REV. A
AS4330

AEROSPACE STANDARD
TUBING, FLARED, STANDARD DIMENSIONS FOR, DESIGN STANDARD

AS4330
SHEET 1 OF 2

ISSUED 1993-08 REAFFIRMED 2005-06 REVISED 2014-04

FIGURE 1 - TUBING END, FLARED

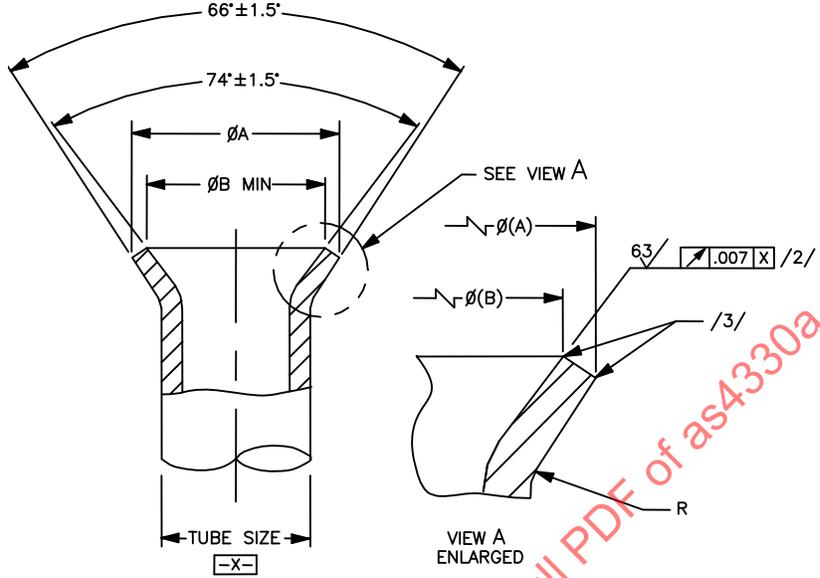
1. CLARIFIED THE INCLUDED ANGLE TOLERANCES IN FIGURE 1.
2. FIGURE 1 AND VIEW "A" REDRAWN TO SHOW TUBE END VIEW AFTER FORMING.
3. CHANGED TITLE IN ACCORDANCE WITH ARP1987.
4. REVISED NOTES TO AGREE WITH KC154.
